Work Order ID 135096

Item Name: Crosstube Turning Detail

DRAWING NO. D206-667-141	TITLE CROSSTUBE ASS'Y (206B HIGH FWD)	REV. C	DART AEROSPACE LTD ENGINEERING ORDER		D.E.O. NO. D206-667-141-C-1	SHEET NO. SHEET 1 OF 1	SCALE NTS
DRAWN <i>q</i>	CHECKED <i>ASS</i>	MFG. APPR. <i>AD</i>	APPROVED <i>WD</i>		DE APPR. <i>A</i>		
DATE 11.07.15	DATE 11.07.20	DATE 11.07.21	DATE 11/07/21		DATE 11.07.21

DRAWING NO. D206-667-141		TITLE CROSSTUBE ASS'Y (206B HIGH FWD)		REV. C DART AEROSPACE LTD ENGINEERING ORDER		D.E.O. NO. D206-667-141-C-2		SHEET NO. SHEET 1 OF 1		SCALE NTS	
DRAWN AJS		CHECKED J		MFG. APPR. E		APPROVED A.P.		DE APPR. H			
DATE 12.08.02		DATE 12.08.02		DATE 12.08.02		DATE 12.08.02		DATE 12.08.02

DETAIL P
BONDING STRAP INSTALLATION-2 PL

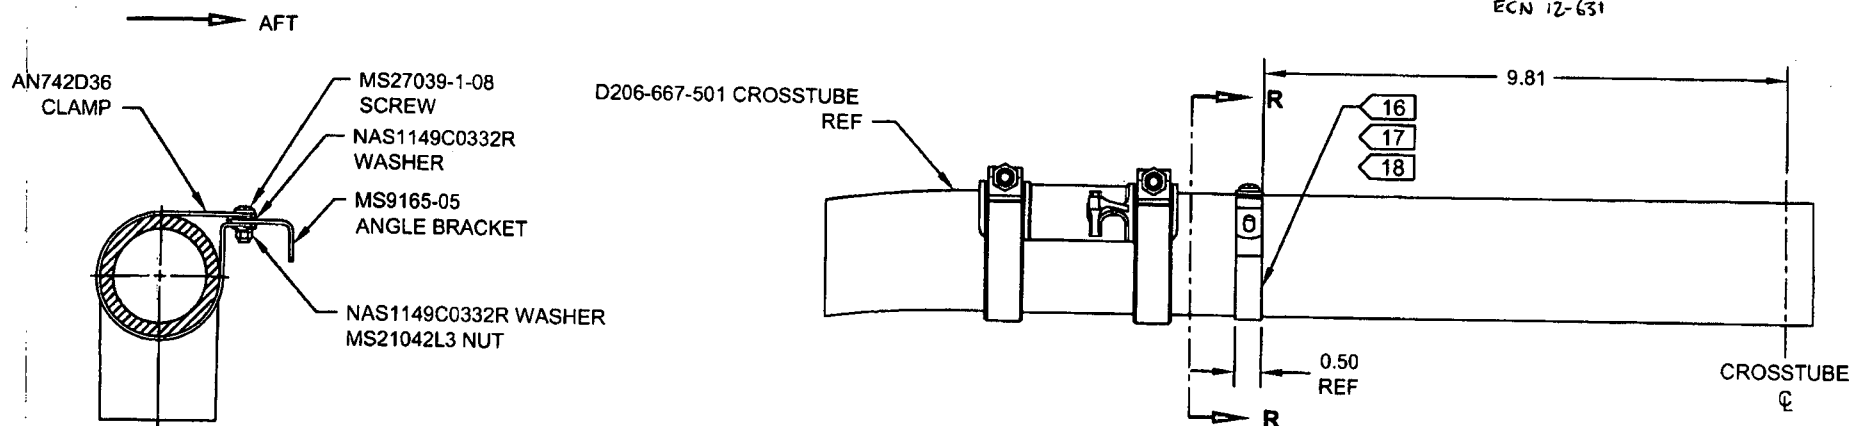
ADD ELECTRICAL GROUNDING STRAP

ITEM	QTY -141	PART NUMBER	DESCRIPTION
1	X	D206-667-141	CROSSTUBE ASSEMBLY (206B HIGH FWD)
10	2	AN742D36	CLAMP
11	2	MS9165-05	ANGLE BRACKET
12	2	MS21042L3	NUT (OR MS21042-3)
13	2	MS27039-1-08	SCREW
14	4	NAS1149C0332R	WASHER (OR AN960C10L)

- 16) MASK AREA UNDER CLAMP PRIOR TO PAINTING
- 17) SEAL EDGES WHERE AN742D36 CLAMP MEETS WITH THE CROSSTUBE USING SIKAFLEX-241/-291 OR MIL-S-8802 CLASS B2 OR PROSEAL 890 SEALANT
- 18) PERFORM RESISTANCE CHECK TO ENSURE MAX RESISTANCE IS 10 MILLIOHMS
